ADDENDUM NO. 4

**BREWSTER CENTRAL SCHOOL DISTRICT
BREWSTER HIGH SCHOOL
SECURITY VESTIBULE, SYNTHETIC FIELD AND RELATED WORK**

DATE: May 7, 2024

This Addendum consists of two (2) pages plus Sketches SK-10, SK-11, SK-12, specification section 32 1413 Brick Pavers, revised drawing BHS C401, C501, C601, C602, C707 & C708.

CB 13 TO ES 1

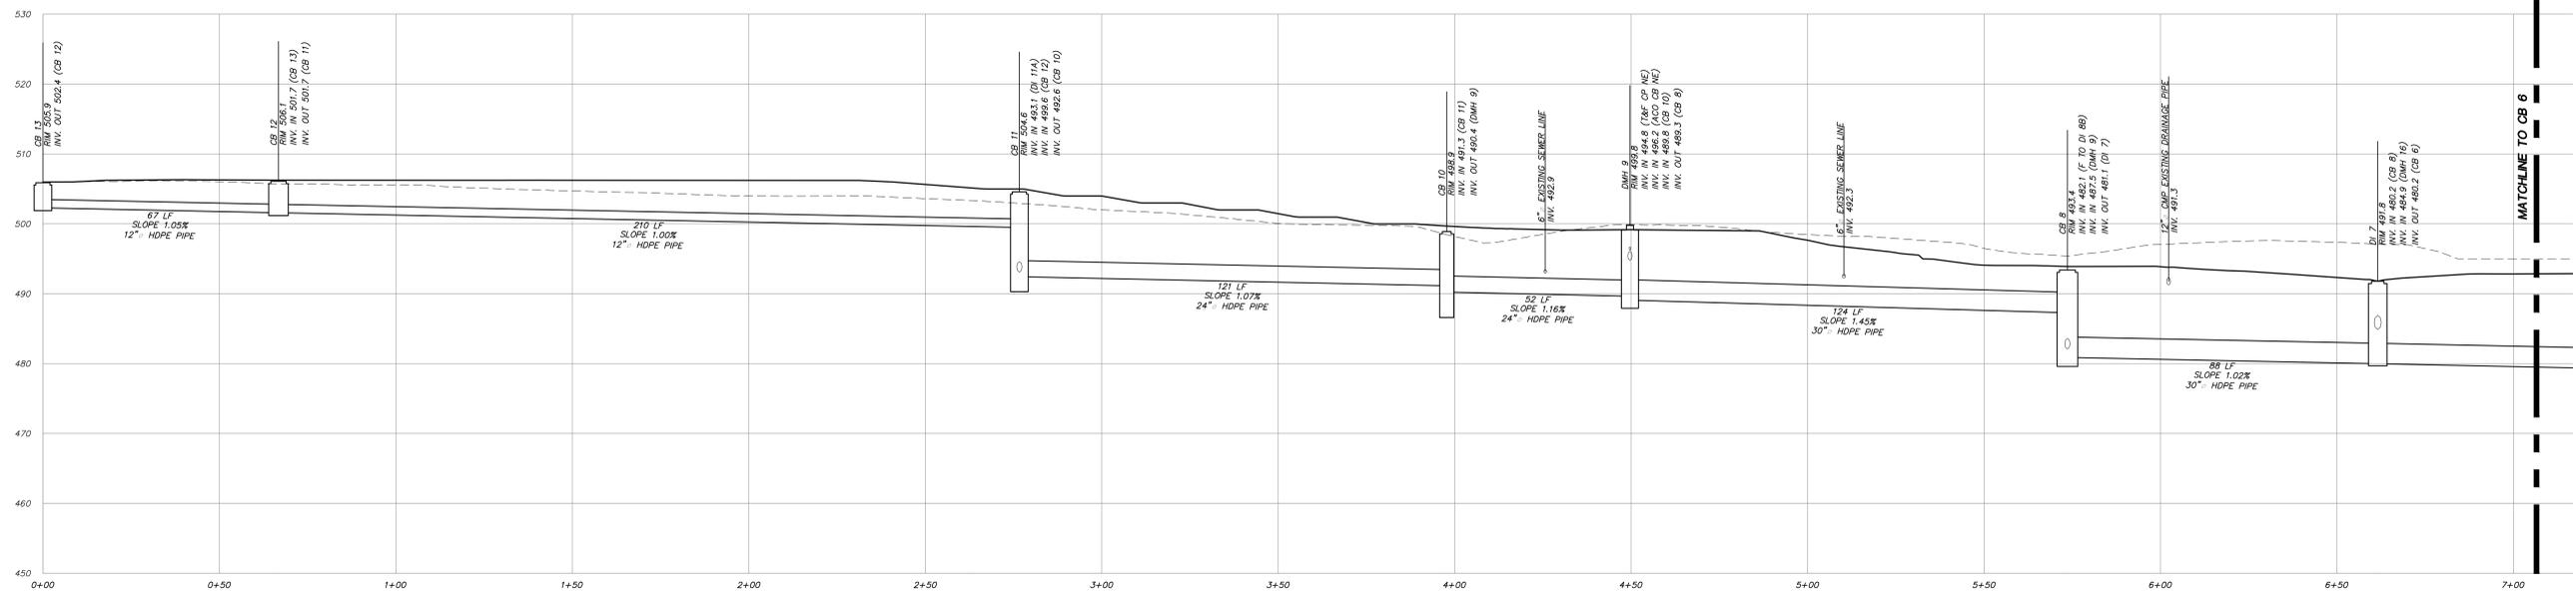
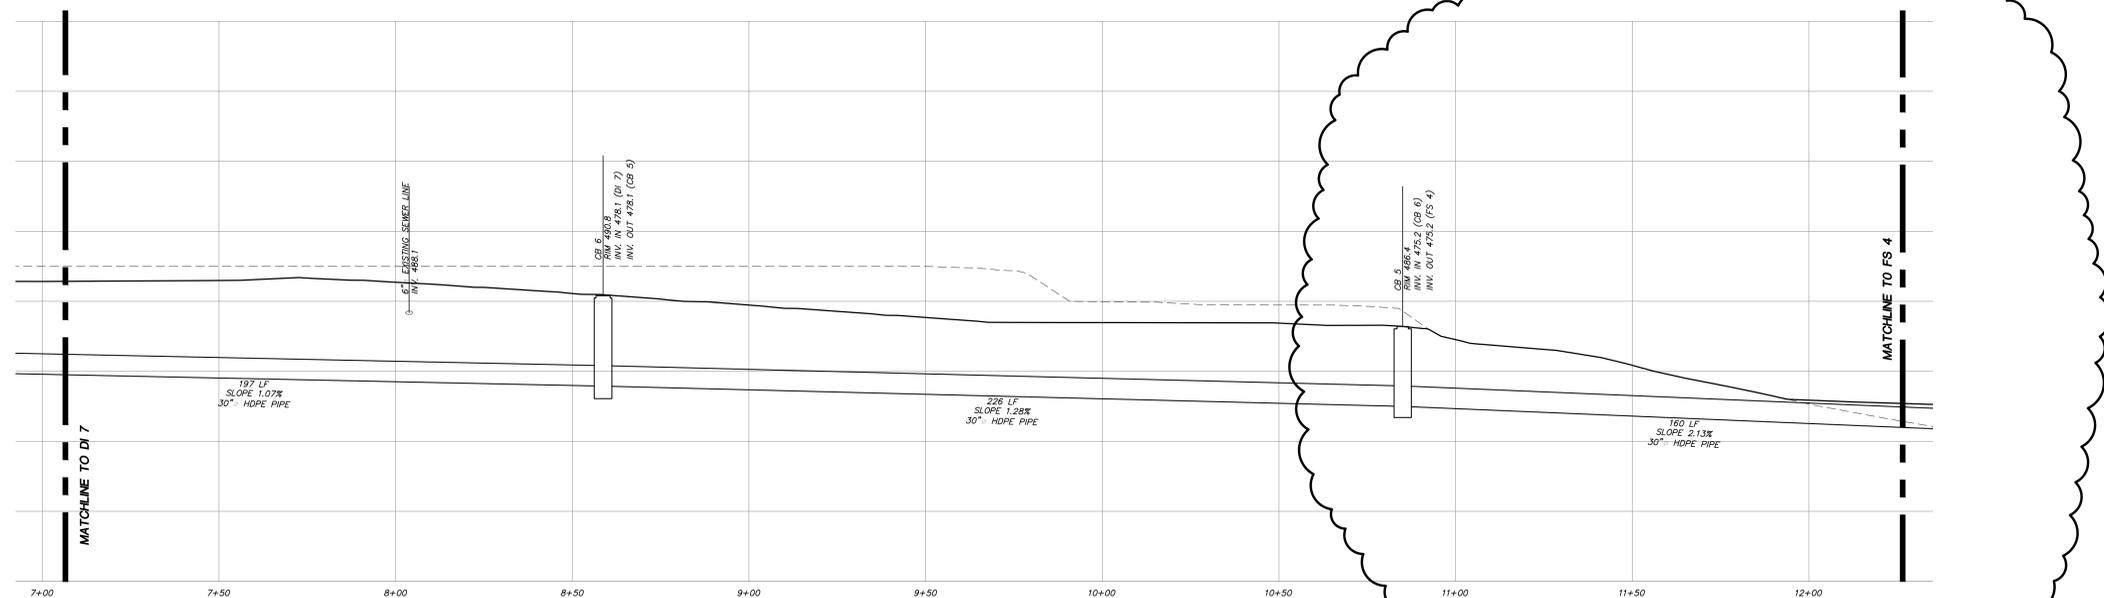
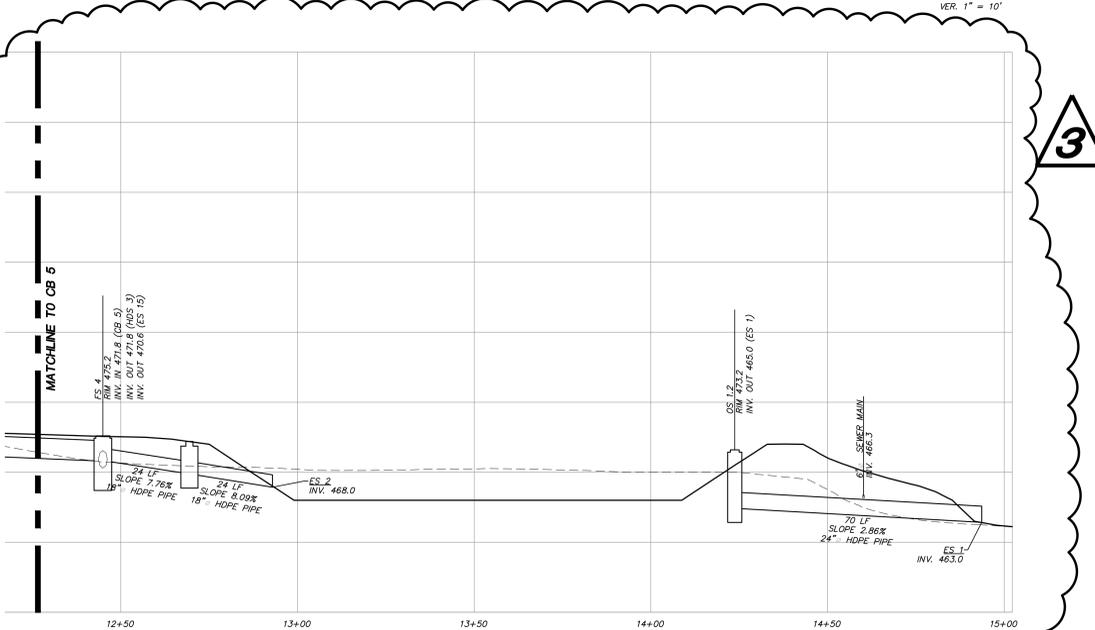
BHS C601 – UTILITY PROFILES

REVISE utility profiles as shown on revised drawing attached to this addendum.

DRAWING TITLE:
 ATHLETIC FIELD, TRACK, AND PARKING AT
 BREWSTER HIGH SCHOOL
 UTILITY PROFILES

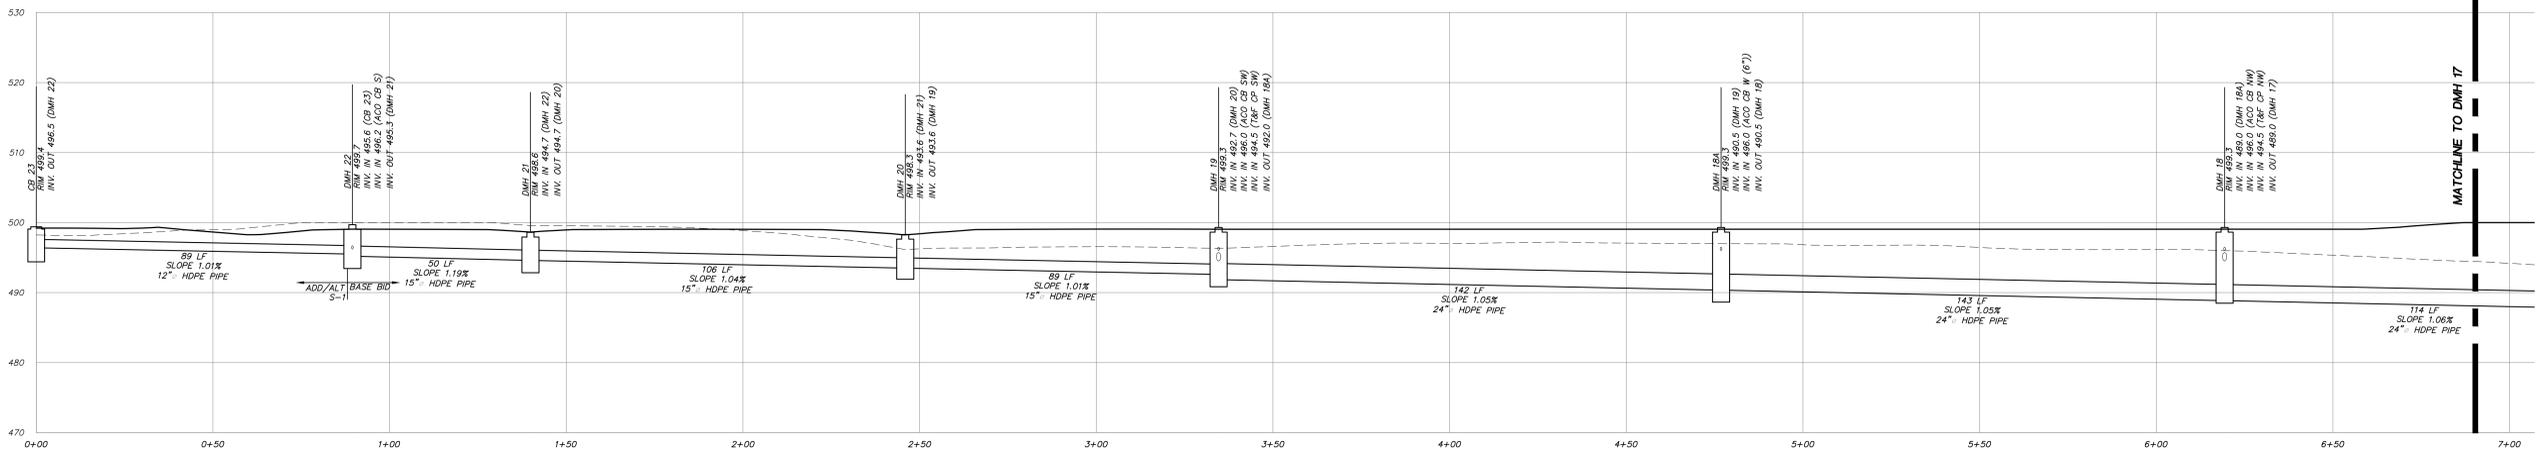
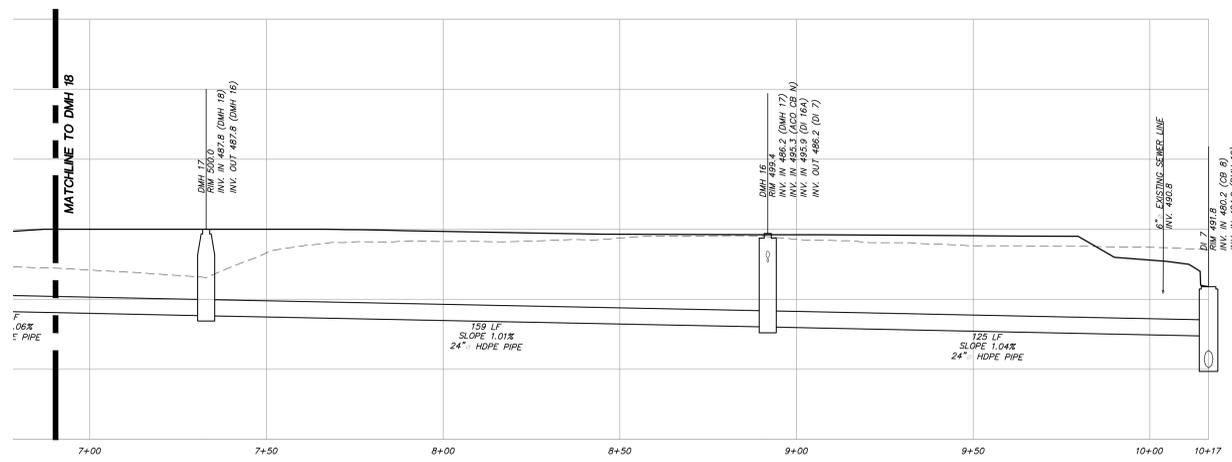
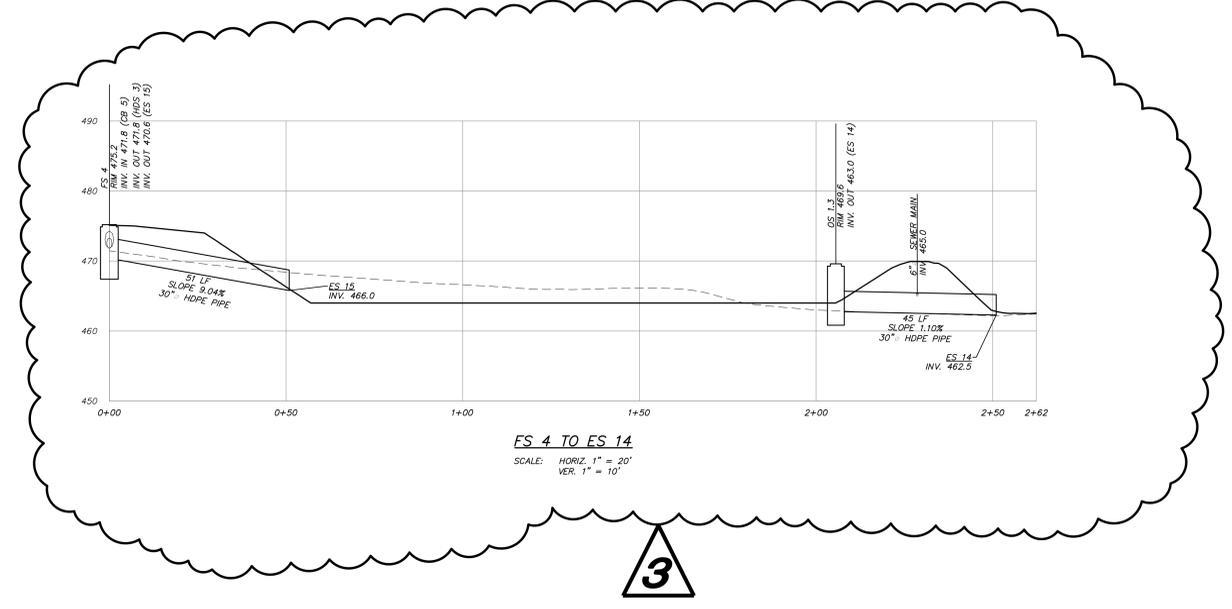
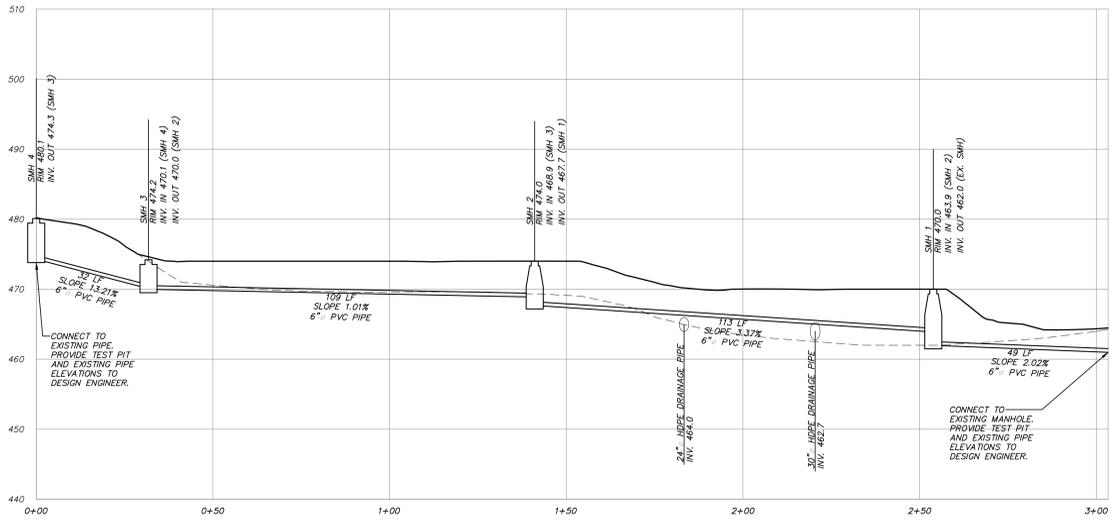
BHS C602 – UTILITY PROFILES

REVISE utility profiles as shown on revised drawing attached to this addendum.

FLOW SPLITTER FS 4 DETAIL
(N.T.S.)

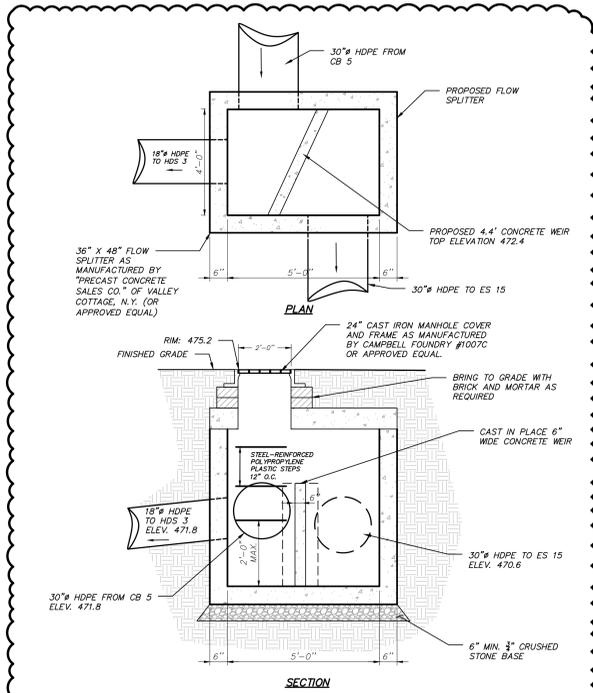
BHS C708 – DETAILS

REVISE Flow Splitter FS 4 Detail as shown on revised drawing attached to this addendum.
